Re: Notice of Intent – 528 Boylston Street

Notice of Intent Application
For Toll Brothers Inc.
528 Boylston Street
Newton, MA
Prepared by: Bohler
Revised: 4-1-2024

GIS Map

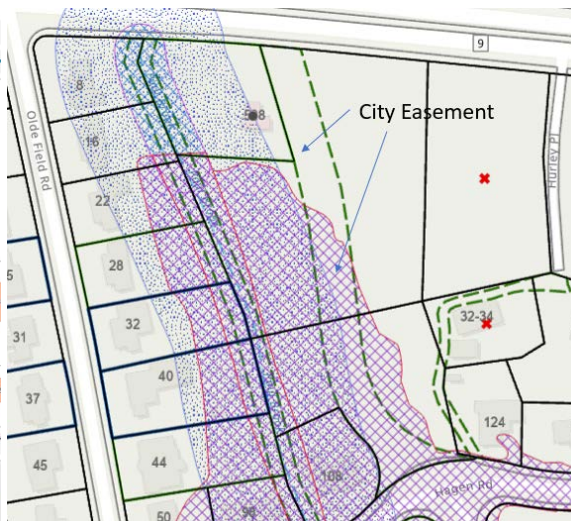
The submitted site plan shows a 12-inch City water main that traverses the property from north to south direction. An existing 45-ft wide easement formerly known as Adeline Road (a paper street) the proposed site plan does not indicate that there is a City Easement as shown on the GIS map.

Paul Brook looking south

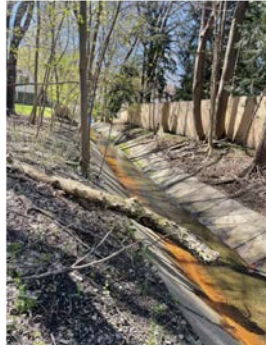
The Engineering Division concurs with the findings of the Alternative Analysis. A significant portion of the site is currently impervious, the proposed redevelopment is to restore these areas to a naturally vegetated area. This will enhance stormwater quality and enhance local wildlife habitat. Although on-site restoration is not required since it does not exceed the standard of 310 CMR 10.58(5) (c), (d) or (e) the applicant is proposing restoration of more than 15K square feet of previously degraded area, and approximately 25K square feet of additional mitigation in areas of the Riverfront. Paul Brook that is a concrete lined channel is in need of cleaning of fallen debris, overgrown plants, and silts the limits of the channel should be part of the restoration plan.
